3. Response to Comments

Draft Environmental Impact Report for the

Estrella Substation and Paso Robles Area Reinforcement Project

Phyllis Fox, PhD, PE

Figure 1: Average Wind Speeds for Paso Robles Airport⁵⁶

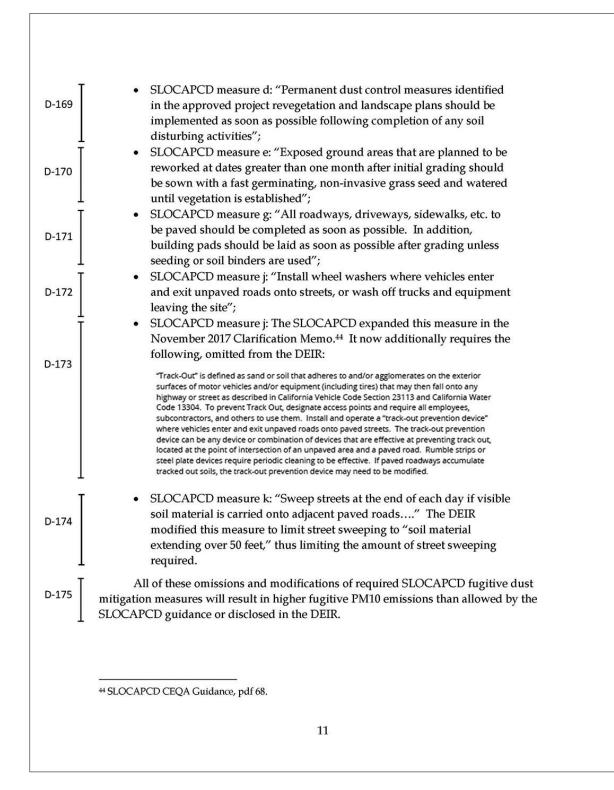
Windblown dust from Project disturbed soils is a particular concern at this site because high winds occur regularly during spring.⁵³ The DEIR fails as an informational document under CEQA for failing to include a wind rose for the Project area, which is known for high winds called the Santa Lucia winds.⁵⁴ Wind speed data for the Paso Robles Airport for the period September 2012 to December 2020 report an average wind speed of 9 mph.⁵⁵ Gusts up to 25 mph occur throughout the year. Figure 1.
